MANUAL CHANGES

Model Number: 1740A
Date Printed: August 1976
Part Number: 01740-90909

This supplement contains important information for correcting manual errors and for adapting the manual to instruments containing improvements made after the printing of the manual.

Service Schematic 4,

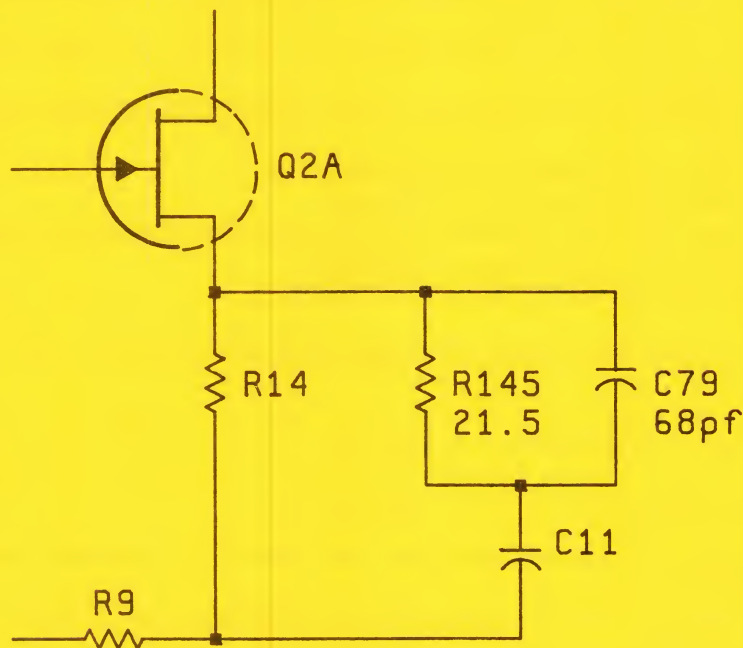
Add: A3R145 and A3C79 in series with A3C11 to Channel A, as shown.

Add: A3R146 and A3C80 in series with A3C25 (same as above) to Channel B.

Schematic 2, Change HV DISABLE Q1/Q2 circuitry as follows:

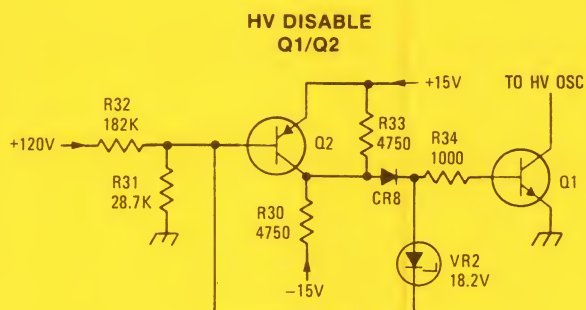
Add: A15CR8, HP Part No. 19101-0040, DIODE-SWITCHING 30V 50MA 2NS D0-35, Mfr Code 28480, Mfr Part No. 19101-0040.

Change: A15R30, HP Part No. 0757-0437, RESISTOR 4.75K 10% .25W FC TC=-400/+700, Mfr Code 24546, Mfr Part No. C4-1/8-TO-4751-F.

Change: A15R31, HP Part No. 0698-3449, RESISTOR 38.7K 1% .125W F TC=+-100, Mfr Code 24546, Mfr Part No. C4-1/8-TO-2872-F.

Add: A15R33, HP Part No. 0757-0437, RESISTOR 4.75K 10% .25W FC TC=-400/+700, Mfr Code 24546, Mfr Part No. C4-1/8-TO-4751-F.

Add: A15R34, HP Part No. 0683-1025, RESISTOR 1K 5% .25W FC TC=-400/+600 Mfr Code 01121, Mfr Part No. CB1025.

Add: A15VR2, HP Part No. 1902-0766, DIODE-ZNR 18.2V 5% D0-7 PD=.4W TC =+.68%, Mfr Code 04713, Mfr Part No. SZ 10939-257.

Schematic 1,

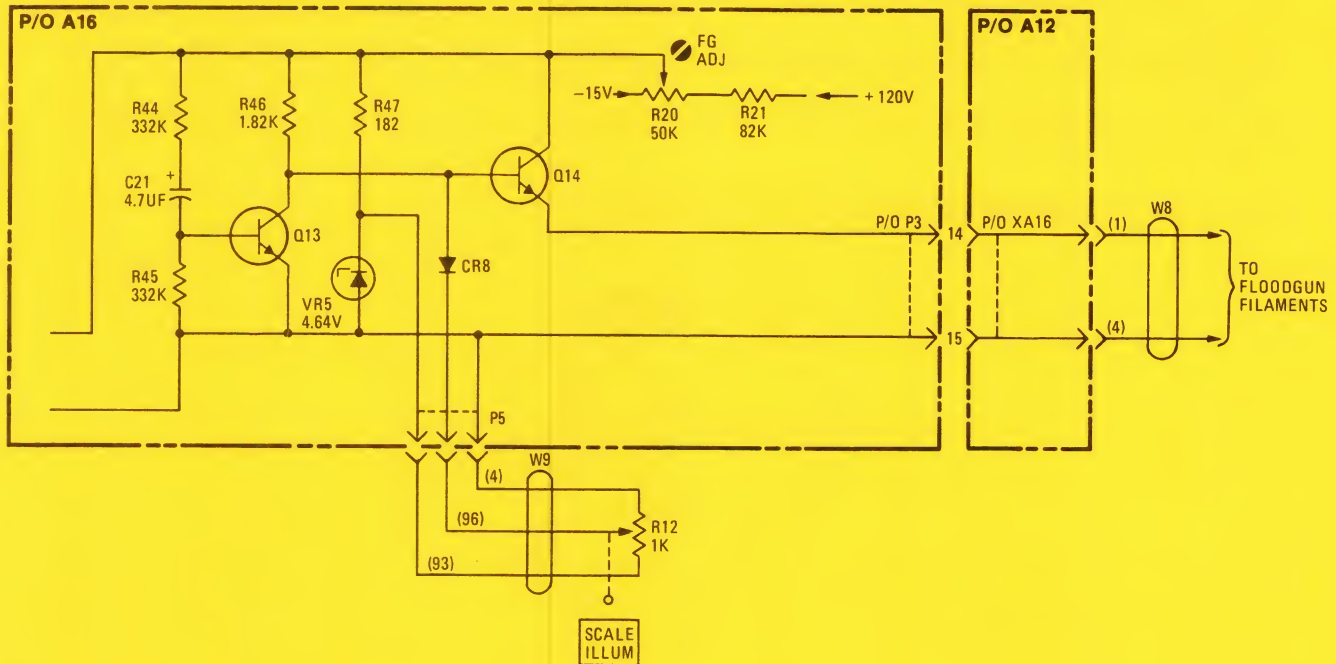
Delete: A16C20, A16Q11, A16Q12, A16R41, A16R42, A16R43, A16VR3, and A16VR4.

Add: A16C21, A16CR8, A16P5, A16Q13, A16Q14, A16R44, A16R45, A16R46, A16R47, and A16VR5 as shown below:

Modify Schematic 1 as shown below:

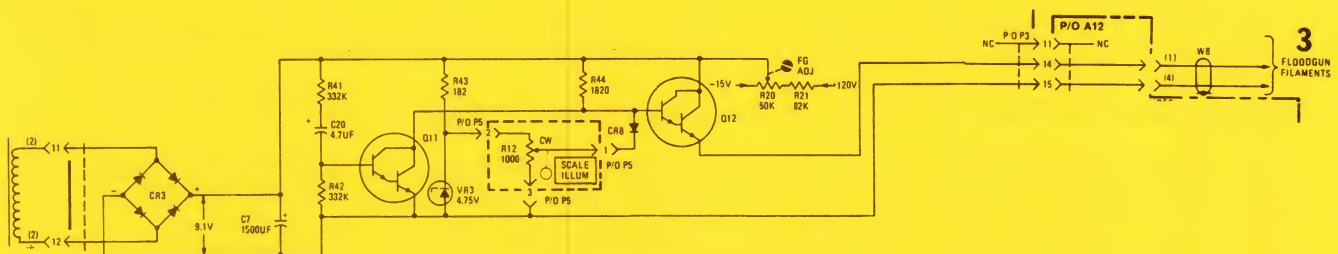
A14: Change HP Part No. and Mfr Part No. to 01740-66540.

A14 Option 101: Change HP Part No. and Mfr Part No. to 01740-66541.

A14XA16: Change to HP Part No. 1251-5092, CONNECTOR 15-PIN, Mfr Code 28480, Mfr Part No. 1251-5092.

A16: Change HP Part No. and Mfr Part No. to 01740-66542.

A16P2: Change to HP Part No. 1251-5093, CONNECTOR 15-PIN, Mfr Code 28480, Mfr Part No. 1251-5093.
